CITY OF LA CAÑADA FLINTRIDGE

PLANNING COMMISSION STAFF REPORT

October 14, 2014 Meeting

Hillside Development Permit 14-20
Second-floor Review 14-20
Setback Modification 14-10

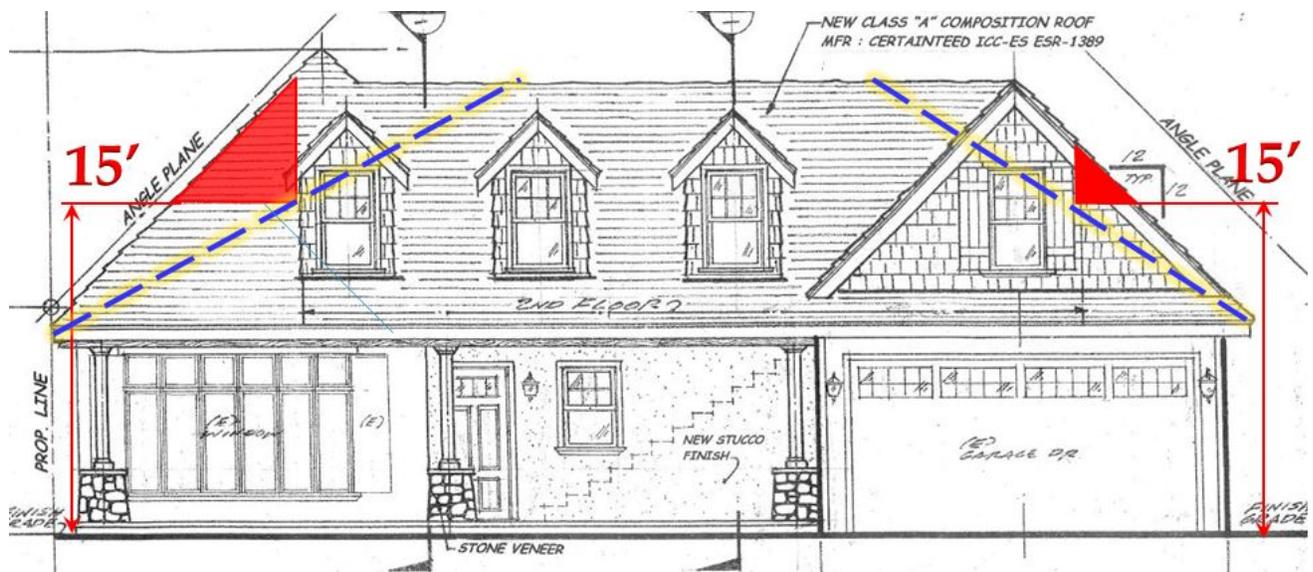
The overall exterior height of the roof sections in question would reach approximately 20 feet to the west and 17 feet to the east, which exceeds the limit set forth in section (C) above. This again is directly attributable to the increased pitch, but also the minimal side setbacks, in particular to the west.

Encroaching roof area would achieve a maximum depth of 5 feet as measured outward from the 2nd-floor setback line to the west. The length of the encroachment would also be minimal, limited to less than half of the west elevation's overall span. This is not especially problematic in staff's estimation given the sloped profile of the hip in question and its gradual recession from the property line. The figure below highlights the encroaching area in the context of the overall roof form, which is minimal to the east, where the provision of a greater setback reduces the encroachment.

While the encroachment could be alleviated somewhat through reduction in the slope of the proposed plane, elimination would require a dramatic change to the roof's profile as indicated in the dashed blue lines. This would have an extreme narrowing effect on the new workout room, likely to a prohibitive extent, and is not regarded as a reasonable option. In all, staff is of the opinion that the roof design as proposed accommodates reasonable 2nd-floor expansion while the main encroachment to the west is a product of the home's existing siting and severe westerly bias, rather than arbitrary or insensitive design decisions. Staff recognizes the tight grouping of the subject home and adjacent residences and the inherent challenges with 2-story construction, but is of the opinion that an adverse crowding effect on the street would not occur, while impacts on adjacent homes would be less than significant.
